[Docket No. NHTSA–2009–0189]

Federal Motor Vehicle Safety Standards; Designated Seating Positions

ACTION: Final rule; response to petitions for reconsideration.

Figure 1: Global Automakers Seat Surface Width Measurement Example

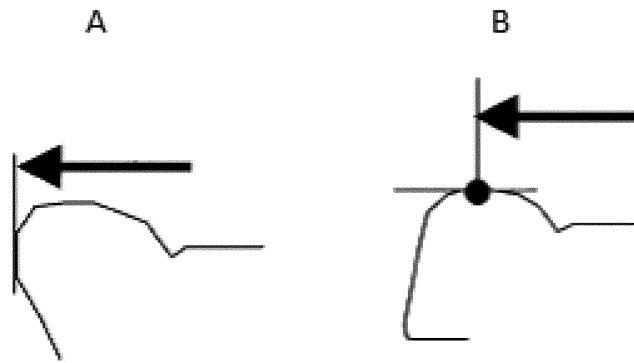
Global Automakers and Toyota requested that the agency clarify its position on how the seating surface width is measured. Global Automakers raised two specific scenarios. The first scenario involves seat cushions whose outer edge slopes downward. Global Automakers was not certain whether the measurement will be made from the outer edge of the seat cushion (identified in A in Figure 1) or the point where the top surface of the cushion begins sloping downward toward the side of the seat (identified as B in Figure 1). Toyota interprets the language as contemplating the seating surface width measurement to take place between the vertical planes tangent to the outboard edges of the seat, as indicated in Figure 2. Toyota stated that if its interpretation is not correct, it was petitioning the agency to adopt its position.

NHTSA agrees with Toyota's interpretation that the seating surface width will be determined from the maximum width between the vertical planes tangent to the outboard edges of the seat. We note that in the context of seat width measurement, the determination of what is outboard is made with respect to the seat orientation and may not align with what is outboard with respect to the vehicle. This measurement procedure is more

objective than the other measurement procedure suggested by Global Automakers. It is not always clear at what point the top surface of the seat cushions begin to slope downward to the side because such surfaces may be rounded or uneven and seat cushions can be pliable.

NHTSA would measure the seating surface width from the plane indicated in drawing A on Figures 1 and 3 above. NHTSA would only consider a trim component in the determination of the seating surface width if the trim makes contact with the top of the seat within the measurement zone. To make this clearer, we are adding specificity to the determination of the "seating surface width."

Figure 3: Global Automakers Seat Surface Width Measurement with Armrest

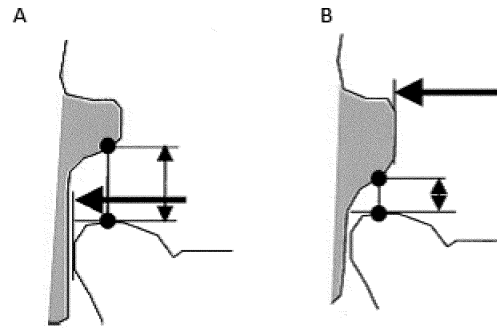
on how the measurement will be taken for seat cushions whose outer edge extends underneath interior trim. Global Automakers noted that, in some cases (one of which is illustrated in Figure 3 below), the interior trim interrupts the "nominal hip room" using the SAE H-point machine and that an occupant could not use the seating surface under the trim.

Shaded area is body-side armrest. 'B' cannot accommodate 3-D manikin in void between armrest and seating surface.

Although the agency agrees that, in Global Automakers' example, some portion of the "seating surface" may not be a location where an occupant could actually sit, the amendment to the DSP definition was designed to make the definition more objective. The new definition is not based upon non-objective concepts such as the usability of the seating surface by the occupant or "nominal hip room." Manufacturers will have to consider the usability of the space in designing the vehicle; however, the DSP definition and measuring procedure make no allowance for seating space that is made unusable by the positioning of trim components such as body-side armrests.

If the seating surface is interrupted by outboard interior trim in contact with the top edge of the seat, the vertical plane used in determining the seating surface width will be the plane that intersects the most inboard point of contact between the interior trim and the point of contact with the top of the seat. We have also added a figure to the regulatory text to illustrate the measurement procedure, including how trim components making contact with the seating surface affect the measurement.

Figure 4: SAE Examples of Seat Measurement with Trim
(Seats in both examples are viewed from above)

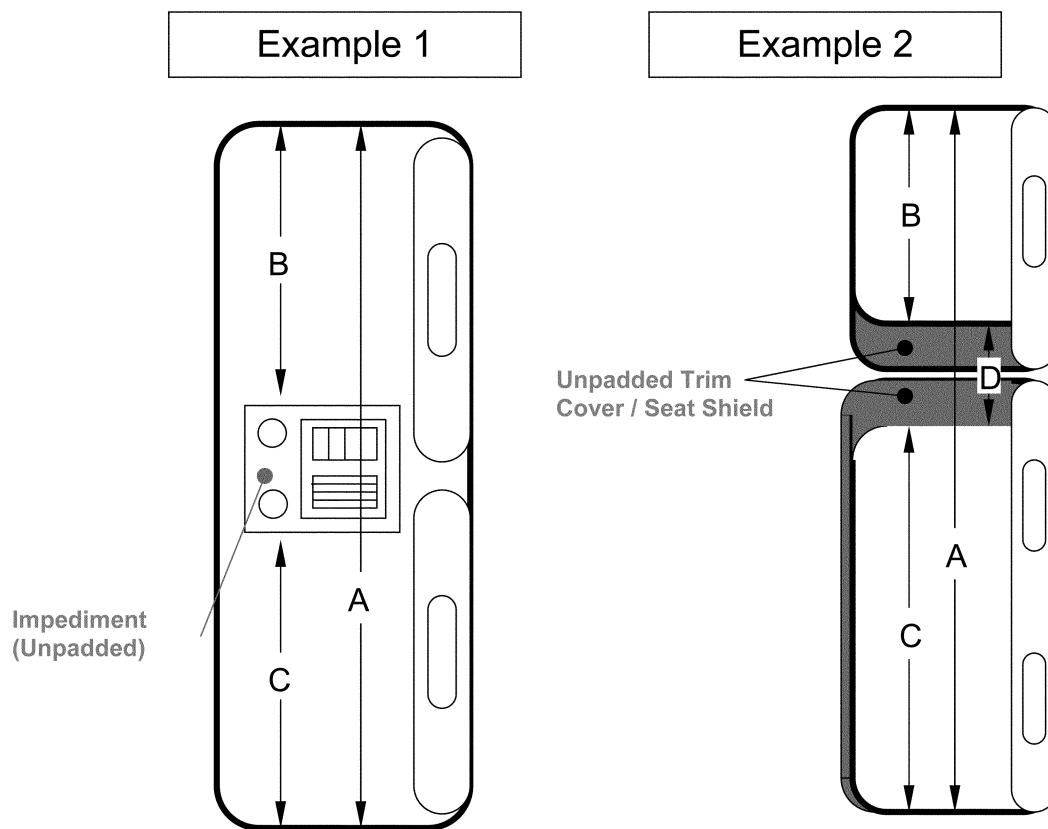
SAE requested clarification on how the agency would consider trim when measuring the seating surface. SAE provided two illustrated examples, shown below, and asked for NHTSA's clarification on how "trim" would be defined.

In Example 1, SAE described an impediment in the middle of the seat as an “embedded convenience system.” During the seating surface measurement, the agency would first determine if the impediment meets the requirements of sections 571.10(c)(2)(i)(A) or 571.10(c)(2)(ii). SAE stated in its request that it was assumed that the conditions of section 571.10(c)(2)(ii) were not met by the impediment.⁷ Therefore, a determination would need to be made as to whether the impediment was “a fixed trimmed surface whose top surface is unpadded and that has a width not less than 140 mm (5.5 inches), as measured in each transverse vertical plane within that measurement zone.” Such a determination is impossible to make from the schematic provided and may only be possible from a physical examination of the impediment. If the impediment satisfied the criteria, the seating width would end at the impediment’s edge, as shown by dimension “B” and “C.” However, if the impediment did not satisfy the criteria, the agency would define the maximum seating surface width as shown by

distance “A” in Example 1. We think this is clear from a reading of section 571.10(c)(2).

SAE asked about the measurement procedure with respect to Example 2. We believe this has been made clear both in the regulation and the agency’s test procedure. Assuming the shaded area is fixed, unpadded trim surface, the determination of seat surface width depends on whether the length of “D” is less than 140 mm. If “D” is less than 140 mm, then seating surfaces “B” and “C” form a continuous seating surface and the number of DSPs would be calculated using measurement “A.” If “D” is at least 140 mm, seating surfaces “B” and “C” would have sufficient separation such that the number of DSPs for seating surfaces “B” and “C” would be calculated separately based on the length of “B” and “C.”
